Staff Report

Tentative Subdivision Plat

SD-04-24

The proposal is to subdivide 1.88 acres of land into 10 lots. The site is located at 2120 Three Lakes Road SE. A location map is included as Attachment A and the proposed Tentative Plat is shown on Attachment B.

TENTATIVE PLAT PLAN

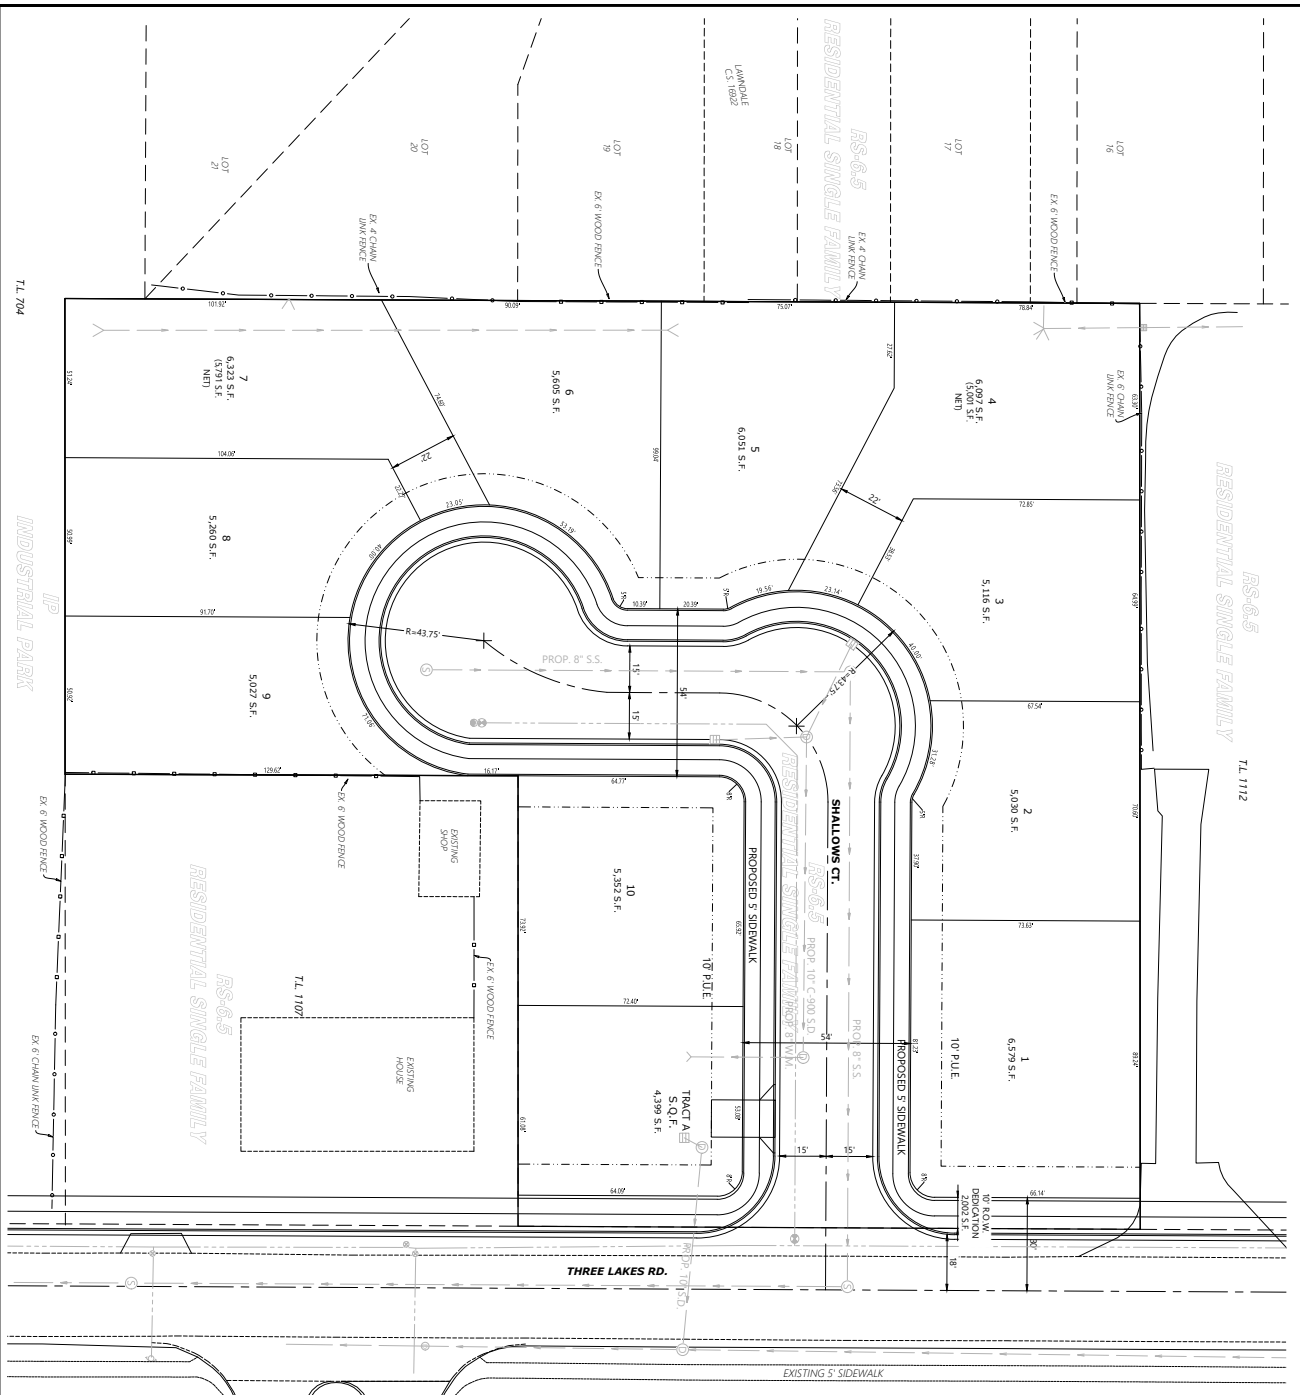
1. Street names will need to be approved prior to final plat. Please submit proposed names to me for approval.

Shallows is not approved at this time.

No more than 30 dwellings can be built before the 2nd access will be required, unless all the structures are fire sprinklered.

4. Dead-end fire apparatus roads in excess of 150 feet in length shall be provided with an approved area for turning around fire apparatus (OFC 503.2.5 and D103.4)
5. The road surface for all private fire apparatus access roads shall be all weather and capable of supporting an imposed load from fire apparatus of at least 75,000 pounds as verified by a qualified State of Oregon licensed design professional. (OFC 503.2.3 & Appendix D, 102.1). The Designer of Record shall provide written certification to the Fire Department upon completion of all private access road construction.
6. This proposed project is located within a "Protected Area" as defined by Oregon Fire Code (OFC) Appendix B, Section B102 and this area is currently served by a public water system. The Fire Flow required shall be as specified in Appendix B of the fire code. (OFC 507.3).

7. INADEQUATE FIRE APPROACH & ACCESS TO WATER SUPPLY
